FW: Proposed Otay Village 14 and Planning Area 16/19

SUBJECT: Village 14 and Planning Areas 16/19: PDS2016-GPA-16-008, PDS2016-SP-16-002, PDS2016-REZ-16-006, PDS2016-TM-5616, PDS2016-ER-16-19-006; Jamul/Dulzura Subregional Plan Area

NEW ROAD CONNECTION

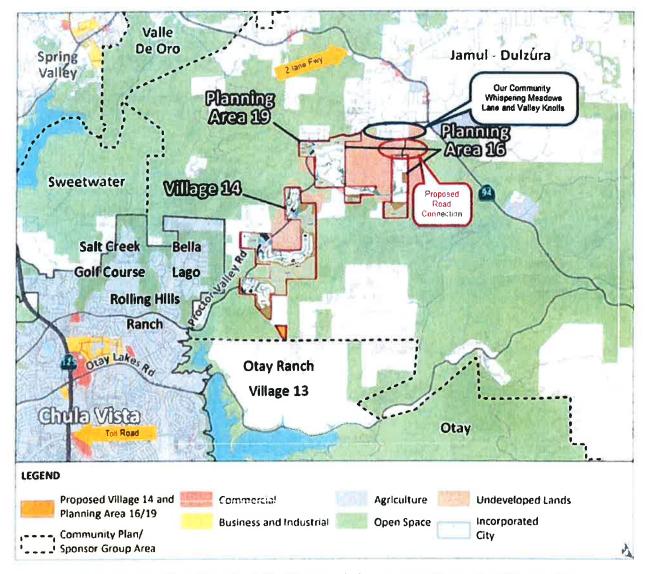
Our first concern relates to the unknowns regarding the "secondary access" being proposed. The developer is proposing to connect Planning Area 16 through two private roads, Whispering Meadows Lane and Valley Knolls Road (a community known as Mountain View Estates). In addition, this proposed road would extend through existing CDFW Lande to connect to Planning Area 16.

This road connection is not in the best interest of the community and we would like to propose a condition be included to require the developer to look into alternatives, such as connecting directly to California State Route 94. Or since this is strictly being proposed as a secondary access, could the existing gate at the end of Whispering Meadows Lane remain locked and only accessible by Fire and County Officials?

IMAGE 1: In this image you can see the locations of the proposed roadways throughout the community. Common sense will tell you that the future residence of Planning Area 16, those particularly in the easterly location will likely use the proposed secondary access through Whispering Meadows Lane and Valley Knolls Road, even if they are traveling to EastLake to avoid roundabouts, etc. However, they will definitely use it if they are traveling to State Route 94 or into Rancho San Diego, which is a shopping destination for the Jamul Community.

HISTORIC FIRES

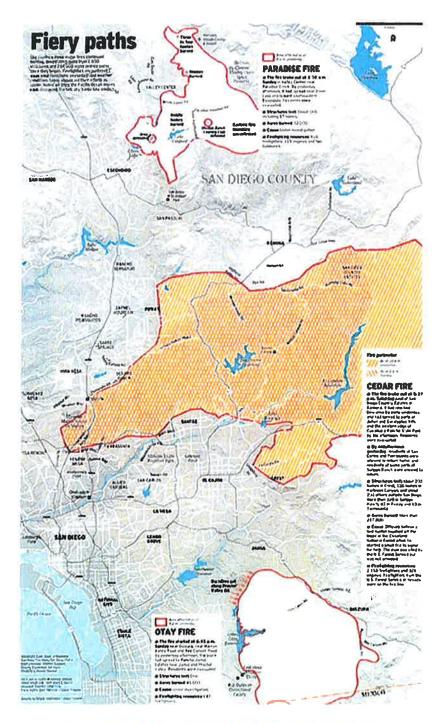
Furthermore, as noted on page 41 of the OV14 Hearing Report, it indicates that it would take approximately 2.5 to 3.0 hours to evacuate the new community in the event of a fire. What does this mean for the neighboring communities? This is very concerning given the recent and tragic Camp Fire in the Community of Paradise. The Paradise Community infrastructure is set up almost identical to how our community would be with the addition of the proposed project. This tragic event clearly tells us that Cal Fire and the Sheriff's Department cannot handle evacuations in such infrastructure layouts. This is not meant to criticize them for all of their efforts, we are simply expressing our concerns, as lives depend on it. Cal Fire was present at the October 19th hearing and made it clear that they accepted the proposed project as it stands. We just don't understand how our community would be any different than the Camp Fire in Paradise, if a fast moving fire were to occur in our area again. If you refer to Exhibit B, you will notice that history tells us that fires move directly through the path in which these proposed communities would be built. The road mitigation to Proctor Valley Road is proposed to remain a narrow two-way road with a limited road shoulder and various roundabouts. Perhaps the new portion of the roadway could be built with a large enough shoulder on both sides allowing two additional lanes for evacuations and emergency vehicles.
